LIBRARY LANTERN CAFÉ REMODEL UNIVERSITY OF CALIFORNIA, MERCED MERCED, CALIFORNIA

Project Name: UNIVERSITY OF CALIFORNIA, MERCED LANTERN CAFÉ REMODEL Project No.: 907016

ADDENDUM NO. 3

July 18, 2017

A2.0

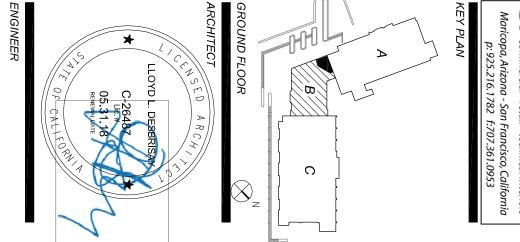
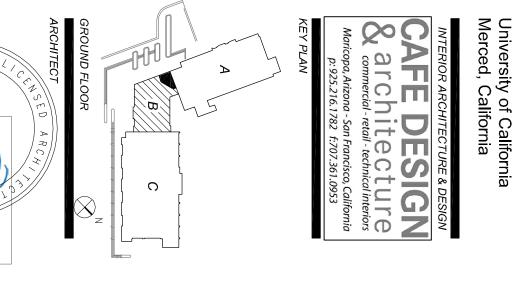
- Q. On all casework: A. Please use Olympus Door and Drawer locks used http://www.olypus-lock.com/products.htm. B. For Refrigerator/Freezer if apply to contractor's scope: Please outfit units with locks prior to deliver/installation. See FS1 and A2.0 attached to this Addendum.
